Model Series 463 AMG: Active Distance Assist and Active Brake Assist IC Message and DTC U0416FE

Topic number	LI54.71-P-078112
Version	4
Function group	54.71 - Camera and radar-assisted assistance systems
Date	7/8/25
Validity	463 AMG
Reason for change	Adding parts for wiring.

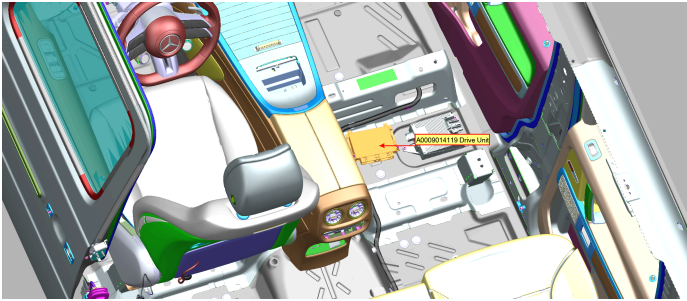
Missing wire between Drive Unit (N145) and Supercap (C8).

Professionally create a new connection by:

- Using a red/white cable with cross-section 0.35 mm² and overall length of approximately 2m.
- Connect Drive Unit (N145) plug A pin 18 to the 3-pin plug of the Supercap (C8) terminal 15 pin 2. Reference the new wire routing location as shown by the red line in "Picture 1 - Connection from Supercap to Drive Unit".
- The new wire should be added to the existing wiring harness as shown by the red line "Picture 1 - Connection from Supercap to Drive Unit".
- Z-Splice is the preferred method using A 000 982 91 10.
- Crimp Contact Pin (MLK) for the Drive Unit (N145) is A0485450328.
